Access Compliance Report Public Rights-of-Way (Curb Ramps)

Main Street: ARADA_ST Cross Street: SOLIDO_ST Location: SW

ADA ID: RPAT211104112846 Ramp Type: Type 1 - Perpendicular Diagonal Initial Pass/Fail: Pass Overall Compliance: No Severity Score: 10

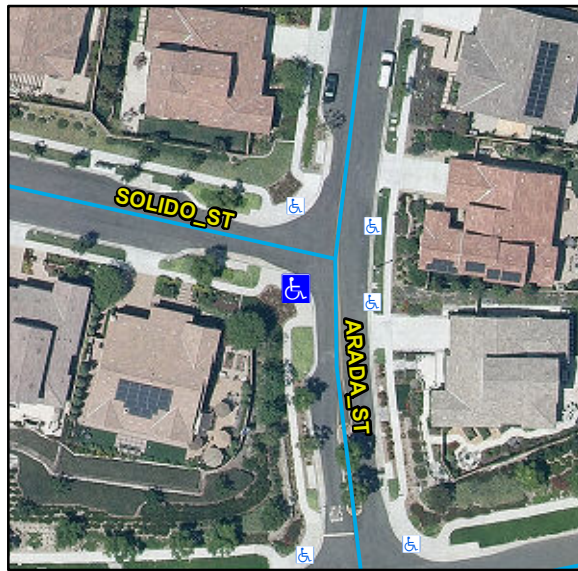
R304.5.3, R304.2.1, R304.5.4, STD 1115

Remove & Replace Curb Ramp With Two New Directional Ramps or Equivalent. Remove & Replace Gutter.
